Technical Bulletin

FORD 1.8 Diesel engine.

GATES REFERENCE :	5541XS/K015541XS
MAKE :	FORD / MAZDA
MODEL :	C-Max, Courier, Fiesta, Focus, Galaxy, Mondeo, S-Max, Tourneo Connect, Transit Connect
ENGINE :	121
ENGINE CODE :	1.8 Diesel (all 8 valves) Various

Fig. 4

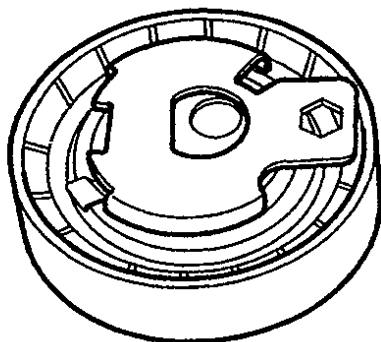
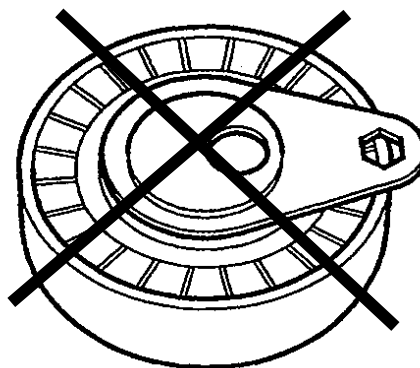
Check if the part number of the camshaft pulley ends with **AC** (Fig. 4). Should the part number of the camshaft pulley end with **AB**, fit new sprocket with OE ref. XS4Q6A256**AC**.

Fig. 6

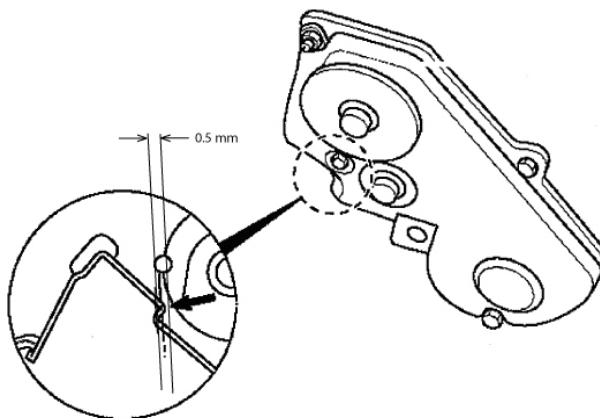
When the manual tensioner is replaced by an automatic tensioner, the timing belt cover has to be slightly modified. File off the inner corner (0.5 mm) as shown in Fig. 6. *Do not damage the timing belt cover by filing off too much of the corner!*
